# DEVELOPMENT REVIEW BOARD REPORT

**89-DR-2004#2**  
**Office Center @ Bell Road**

Request approval of a site plan and elevations for a two-story office building.

① MASTER SITE PLAN

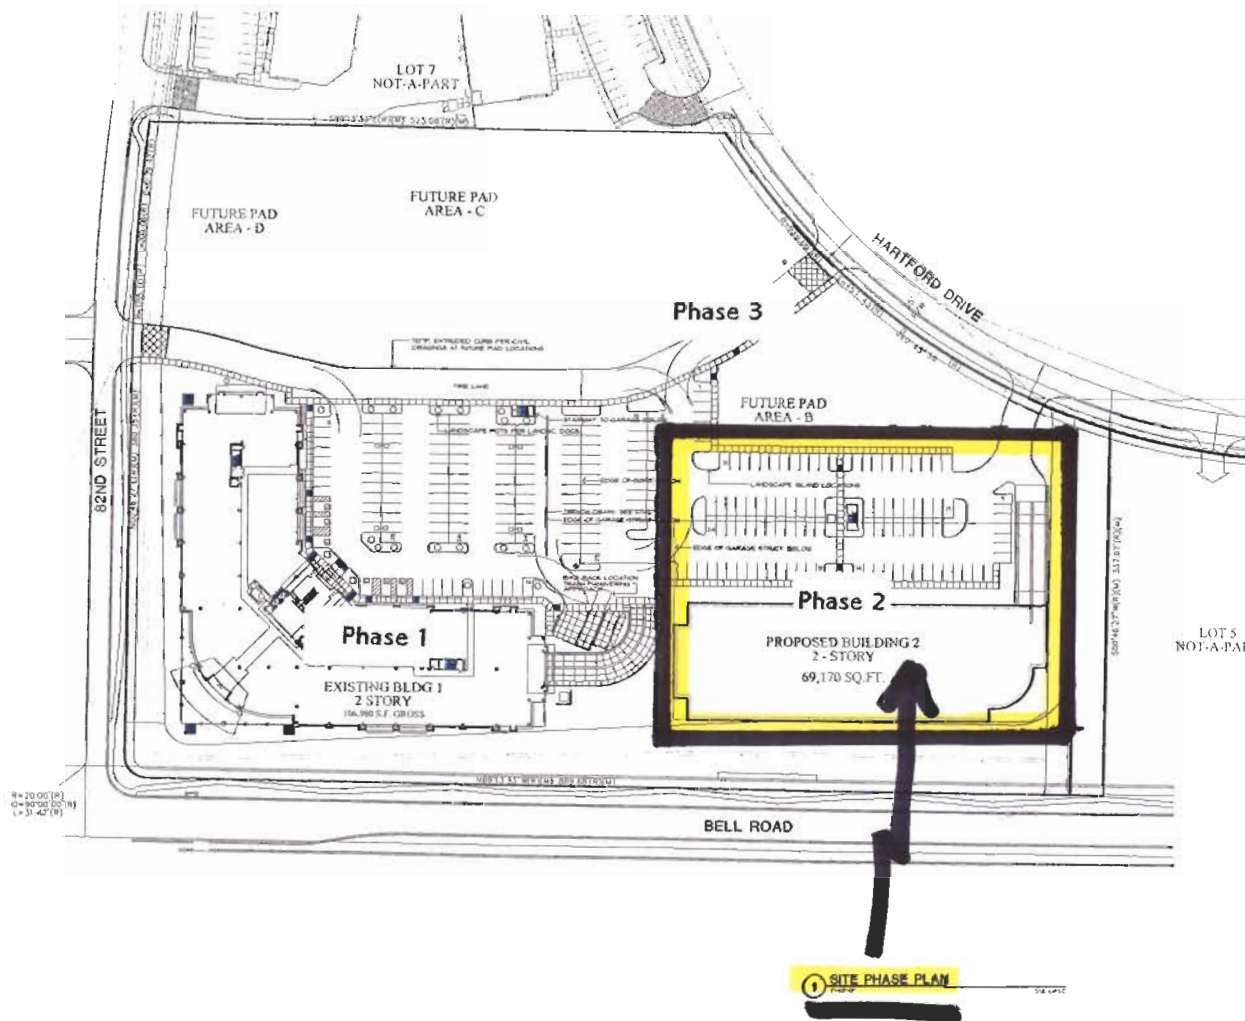
- b. The location and configuration of all site improvements shall be constructed to be consistent with the site plan submitted by Butler Design Group and dated 04/18/05 by City staff.

- 9. Buildings 3 through 5, as shown on the site plan, shall return for separate review and Development Review Board hearing.

- E. Developer shall demonstrate that Building 2 complies with the building setback (or "front yard") requirement pursuant to the Industrial Park District (I-1) property standards in the Zoning Ordinance, at the time of Final Plans review for building permit.

- M. Demonstrate compliance with the Lot Coverage requirement of the Industrial Park District (I-1) in conformance with the Zoning Ordinance.
- N. Revise gross floor area calculations to include all staircase(s) and elevator areas, in accordance with the Zoning Ordinance definition of Gross Floor Area.

ATTACHMENT #6

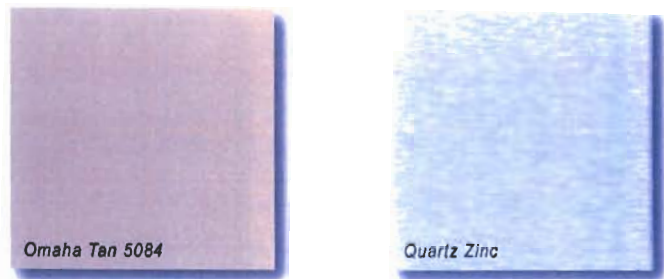
- a. Architectural elements, including dimensions, materials, form, color, and texture, shall be constructed to be consistent with the building elevations and elevations color and materials sheet submitted by Butler Design Group and dated 04/18/05 by City staff.

- C. Developer shall show the calculations used in determining the benchmark for measuring the building height. With Final Plans submittal the elevations shall be revised to demonstrate compliance with the building height maximum, as defined in the Zoning Ordinance.
- D. All roof-top mechanical equipment shall be screened to the height of the tallest unit. With Final Plans submittal indicate mechanical equipment and the roof deck as dashed lines on the elevation drawings, and label as mechanical equipment and roof-deck beyond.
